Report to the Future Melbourne (Planning) Committee

Planning Permit Application: TP-2019-979 292–294 and 296–300 City Road, Southbank

PLANNING PERMIT APPLICATION

Figure 15: Discussion Plans (13 July 2021) showing an adjusted floorplate

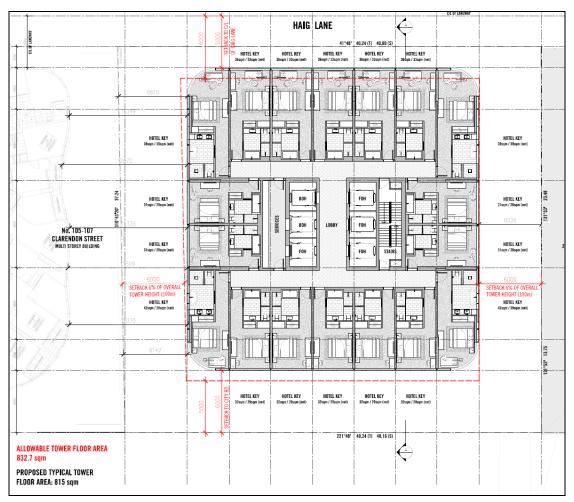
On its merits, the informal plan submitted to Council on 13 July 2021 (refer Figure 15) responds to the Modified Requirement and Built Form Outcomes insofar as:

- The proposed tower floorplate does not result in an increase from the base floorplate;
- The tower is not situated less than 5m from a street boundary (City Road);
- The tower is not situated less than 5m from a side or rear boundary (including the centreline of Haig Lane);
- Tower separation is greater than 10m from the adjoining Shadow Play tower;
- The siting adequately addresses privacy, outlook, daylight and sunlight impacts;
- The tower separation ensures there are no visual impacts in the round;
- Wind impacts are addressed at Section 9.5.2 of this report;
- There is no overshadowing of public spaces identified in Section 9.5.3 of this report; and
- There would be no negative impacts on nearby heritage buildings, discussed throughout this report.

The additional 1m setback from City Road could be formally introduced by way of condition in any permit granted to ensure the tower floorplate complies with DDO10 – **refer recommended Condition 1a**.
